ADDENDUM NO.: 3

Description: Furnish, Deliver, and Install AV

Project: CCNY Aronow Theater

Specifics of the Addendum: The purpose of Addendum No. 3 is to respond to Requests for Information.

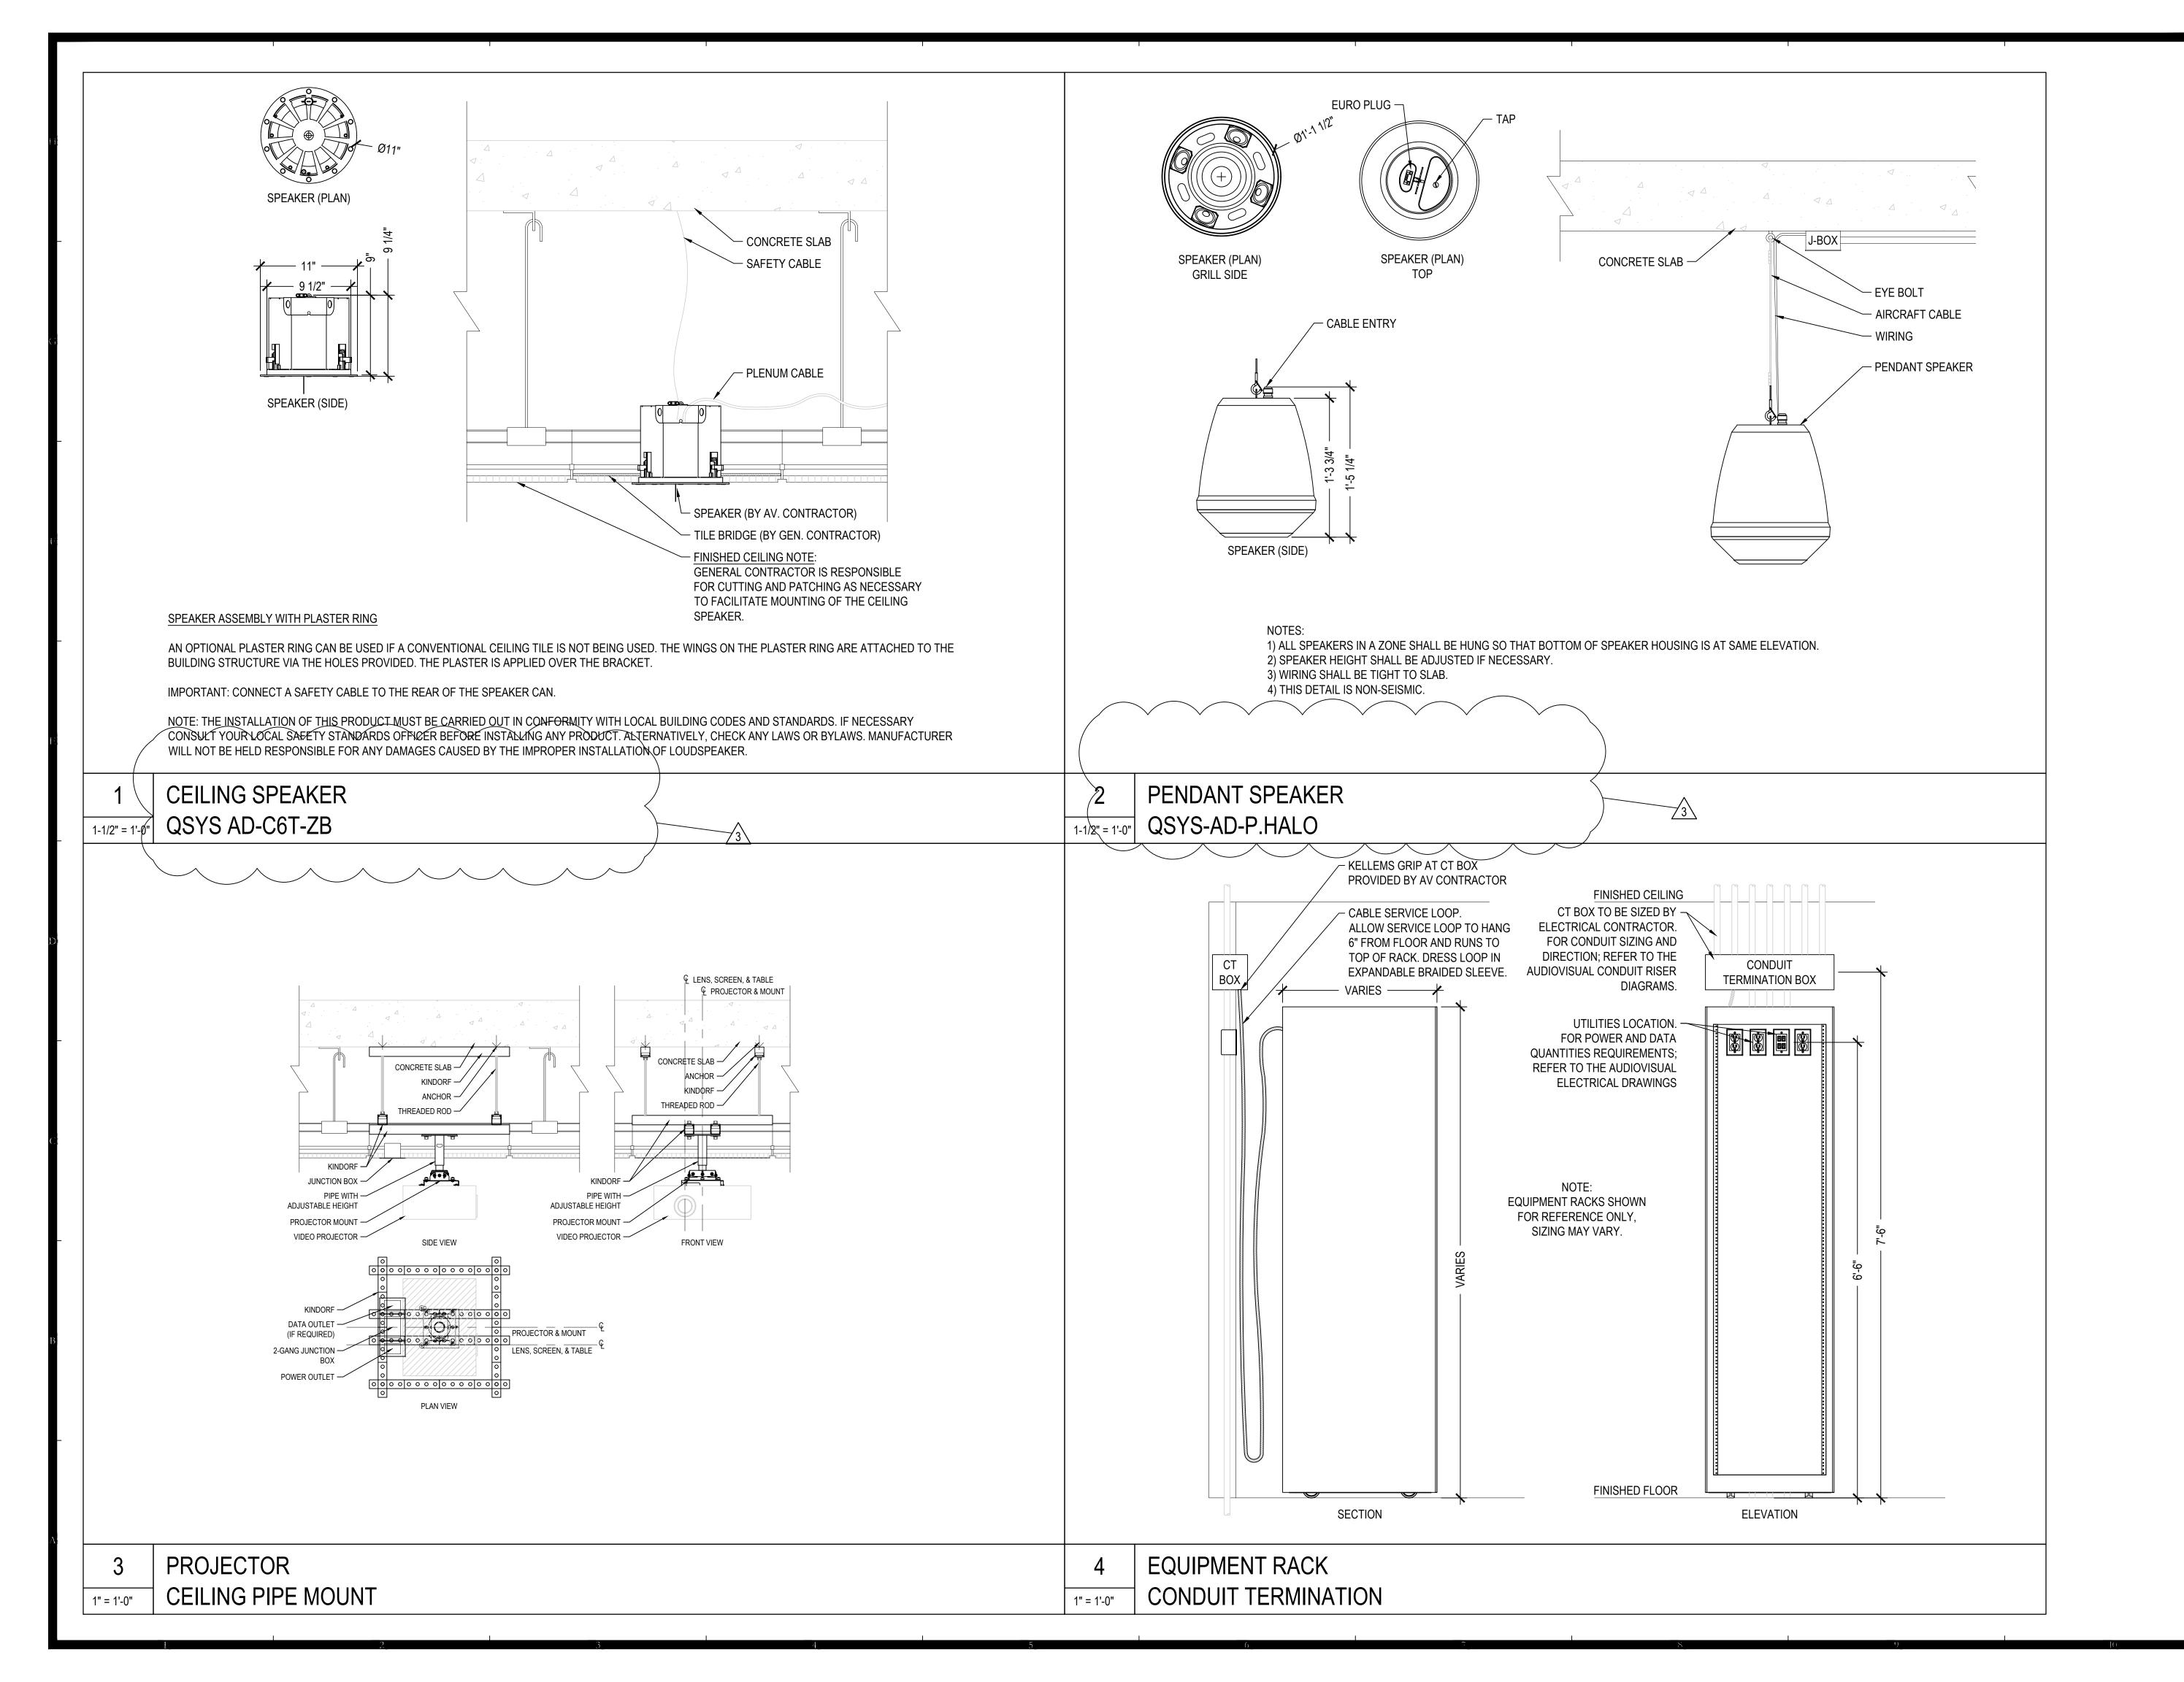
- **A12.** Brightsign is not included in the BOM. Signage hardware is incomplete.
- **Q13.** After reviewing the BOM and flow sketches, we noticed mismatches in the listed quantities. Could you please confirm which quantities we should consider for re- installation and integration with the new system?

Make & Model	Qty in Sketches	Qty in BOM	Notes
TOA HS1500WT	2	4	
Biamp Tesira SIC-4	7	5	
Beyerdynamic RM 3 ⁻ RC	1 0	1	
Crestron DM-RMC-4KZ 100-C	0	1	
Crestron DM-RMC-4KZ 100-SC	⁻ 1	1	We assume this refers to DM-RMC-4KZ-SCALER-C. Please confirm.
Crestron DM-TX-4KZ 302-C	0	1	
BrightSign XD5	0	1	Please confirm the exact model number.
Shure QLXD4=-G50	15	4	
Crestron HD-TXC-101 C-E	⁻ 1	0

Make & Model	Qty in Sketches	Qty in BOM	Notes
Crestron HD-TX-101-C-E	3	0	
Network Switch (TBD)	1	0	
Magewell USB Capture HDMI Gen 2	[;] 1	0	
Crestron HD-RXC-101- C-E	. 1	0	
Crestron HD-RX-101-C-E	. 1	0	
Shure MX418/C	1	0	
Biamp Tesira SEC-2	2	0	
TOA HS-1200WT	4	0

- **A13.** This was a functional existing system, uninstalled and stored for later install and should be installed as is. Once awarded the AVC will have an opportunity to confirm the BOM against the hardware.
